YUKON ENERGY CORPORATION

2017/2018 GENERAL RATE APPLICATION
ROUND 1 INTERROGATORY RESPONSES FILED
ALTERNATIVE GRA FORECAST PER 2017-08

December 18, 2017

Figure 1: Updated: Annual Ratepayer Costs - LNG vs New Diesel: 2015-2018
(LNG Capital Cost at \$23.63 million)

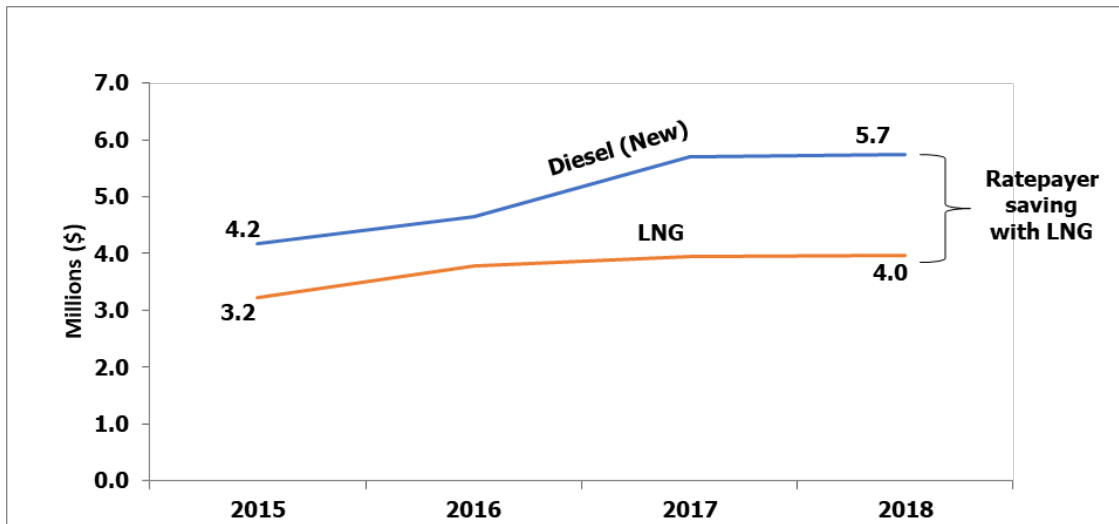
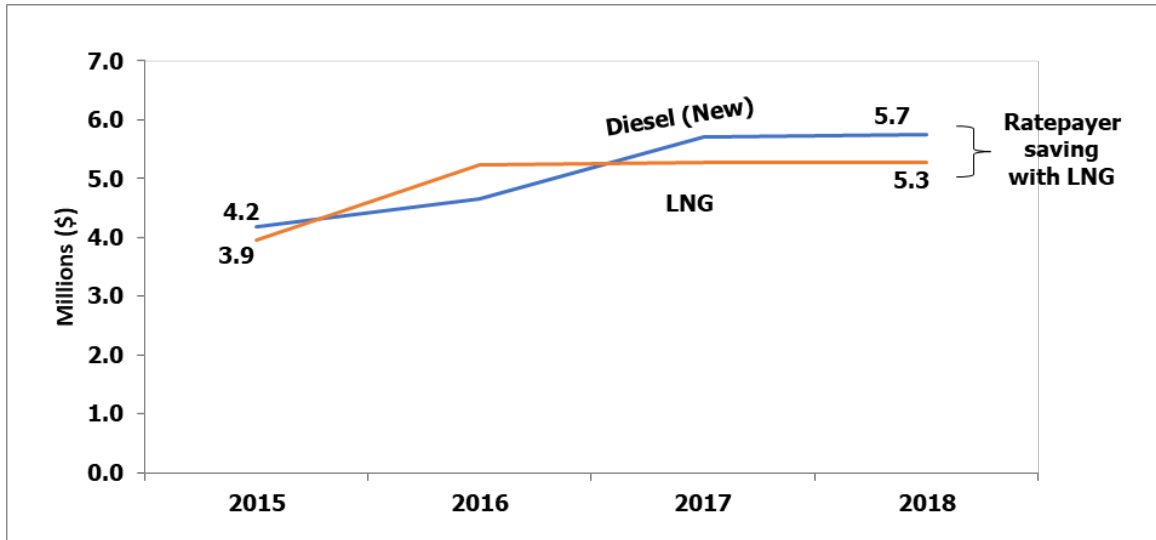
- 28
- 29 i) YEC's LNG Application on page 10 in Figure 3-1, and in the table below it, provides
- 30 a graphical figure and a table of ratepayer costs for capital and fuel costs with new

23
24 Figure 3-1 and related table in the 2013 LNG Application were derived from the analysis
25 in Table 4.3 of the Application. This information was updated in the 2014 hearing in Ex. B-
26 13.

Figures 1 and 2 below provided the updated Figure 3-1 with and without YDC's \$18.3 million contribution towards the LNG plant capital costs. John Maissan-YEC-1-27 Attachment 1 provides the supporting updated Table 4-3.
